ECQ method

(comment R2-205 and others)

Piers Dawe

Comment R2-205

Figure 180–10—Illustration of the TDECQ measurement

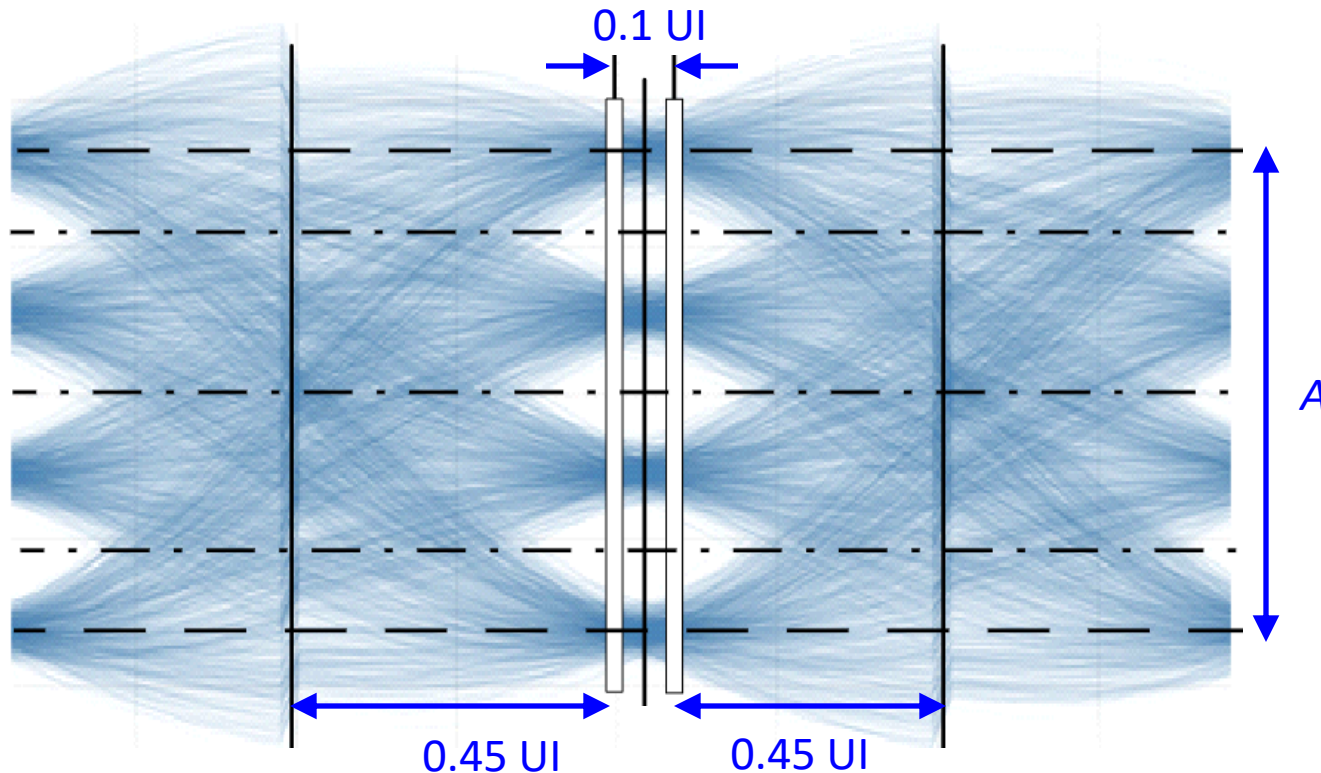
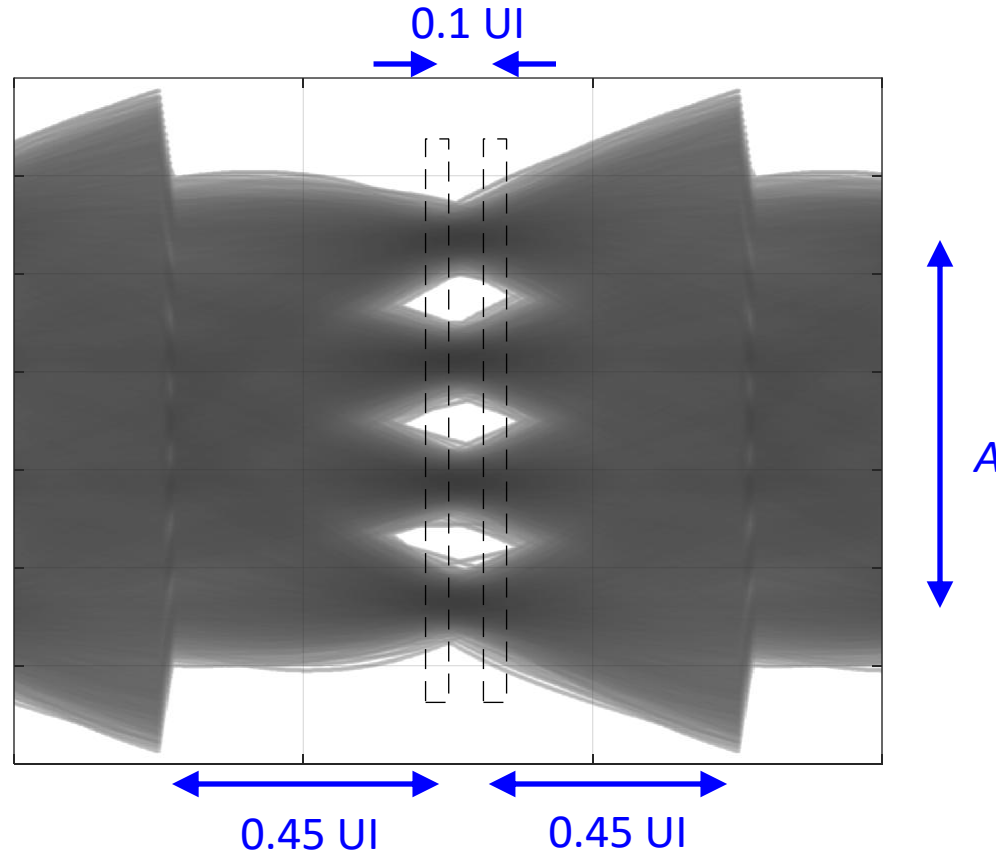
- If available, replace the graphic with one with the correct histogram window widths, transparent histogram windows, without the three vertical lines, and with the feedback transitions at 180° from the histograms, as illustrated on the next slide
- No need to label the horizontal lines, which could be left out too

Figure 180–11—TDECQ reference equalizer functional model

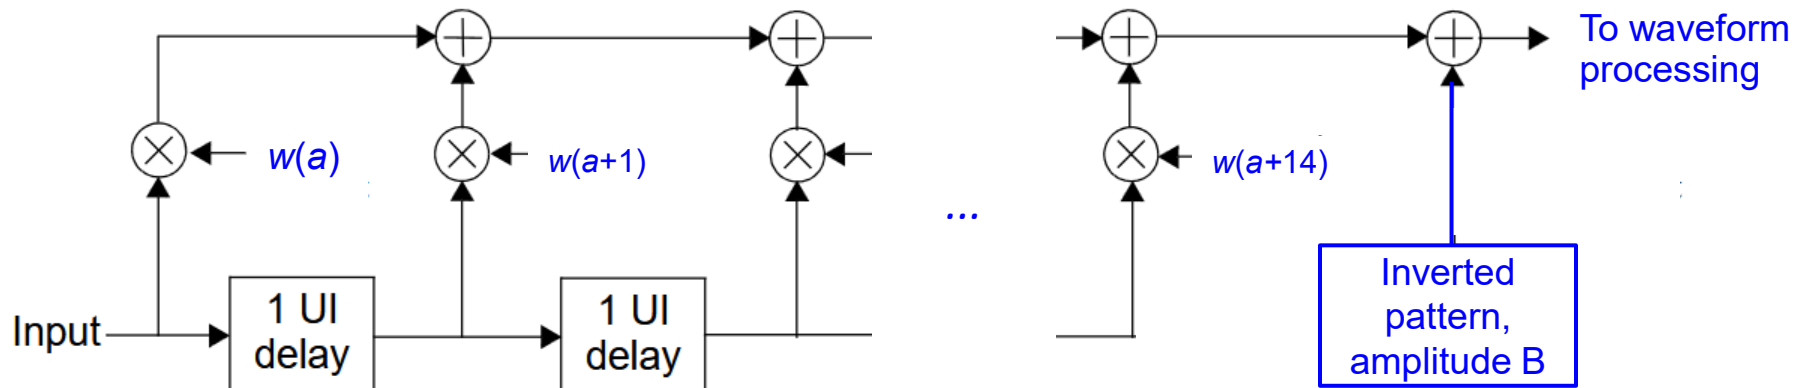
The reference equalizer has 15 T -spaced feed-forward taps, where T is the symbol period, and a pattern generator representing a single decision feedback tap. This feedback pattern is an inverted and level-shifted copy of the test pattern, with timing representing feedback from the previous unit interval. It is added as a high bandwidth signal with levels $-B/2$, $-B/6$, $B/6$, and $B/2$, changing value 0.5 UI after the mean timing of the histogram windows, as shown in Figure 180–10. The peak-to-peak amplitude B is to be optimised along with other tap coefficients, the three thresholds, and the timing of the pair of histogram windows, subject to the limit for $b(1)$, where $b(1) = B/A$. A functional model of the reference equalizer is shown in Figure 180–11; the reference equalizer tap coefficients are specified in Table 180–16.

Figure 180–10—Illustration of the TDECQ measurement

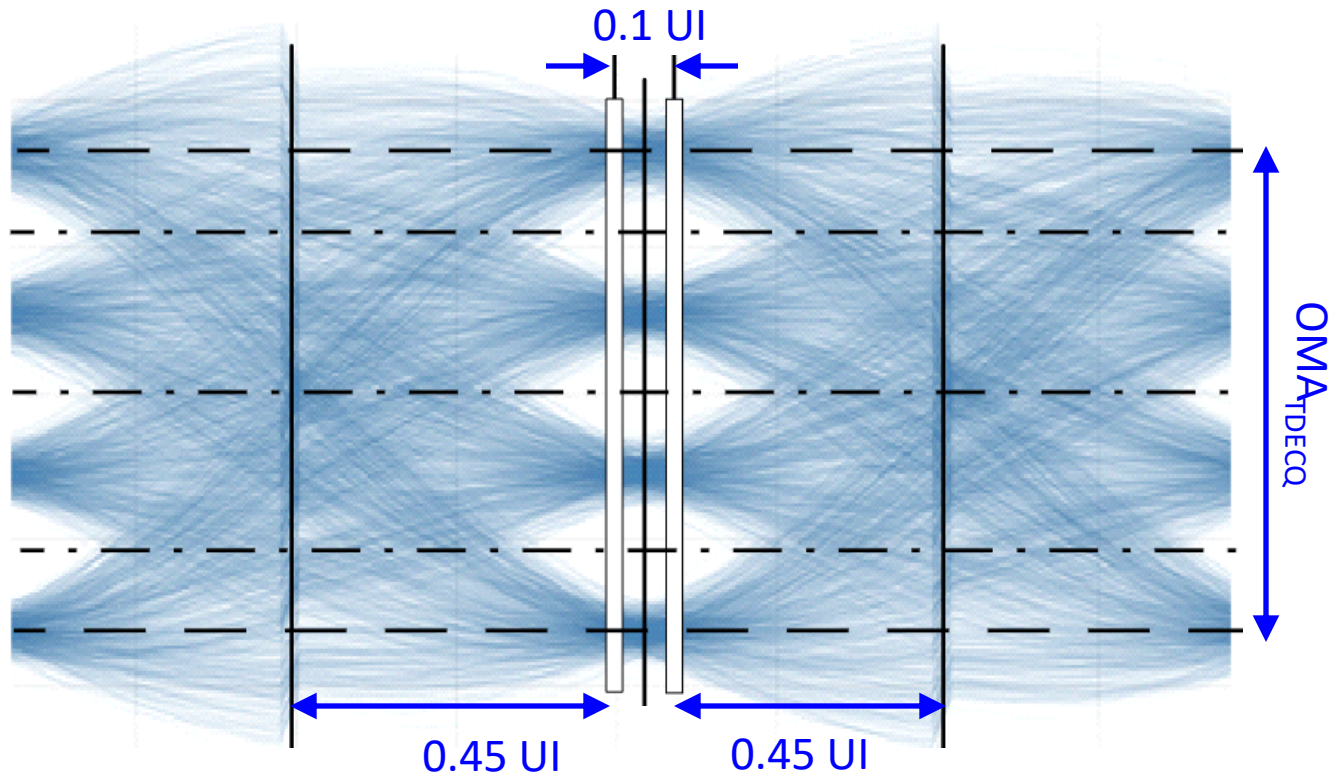
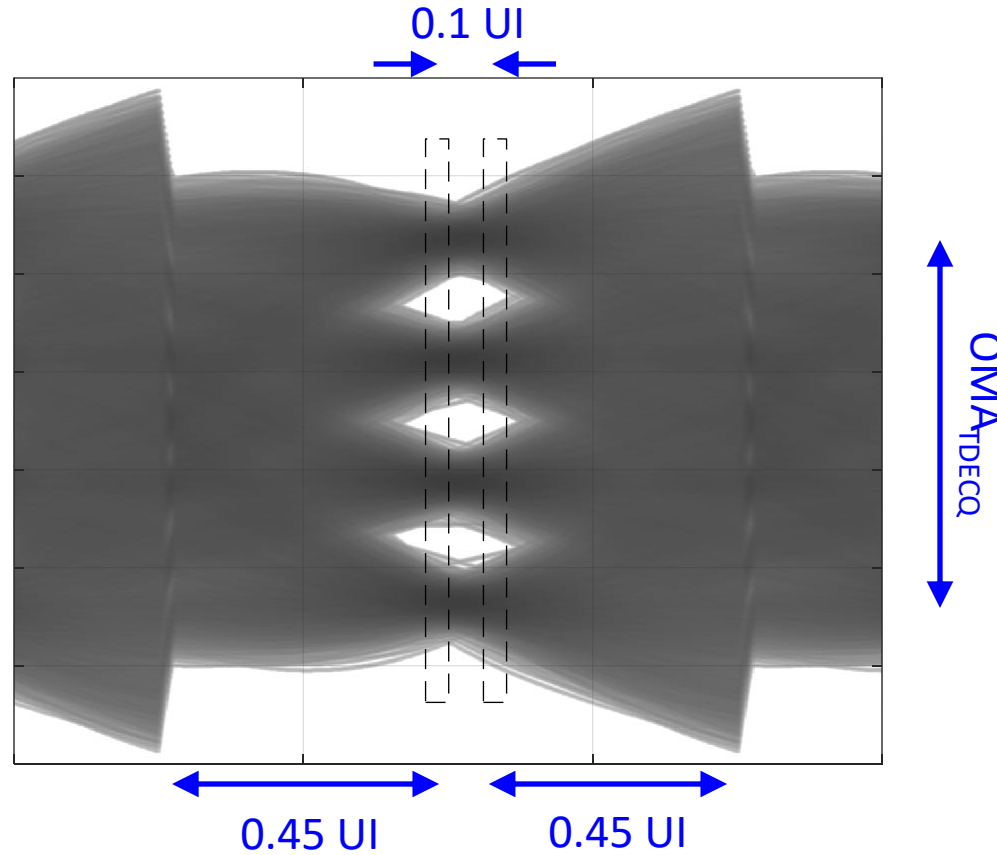
- If available, replace the graphic with one with the correct histogram window widths, transparent histogram windows, without the three vertical lines, and with the feedback transitions at 180° from the histograms, as illustrated on the next slide
- No need to label the horizontal lines, which could be left out too
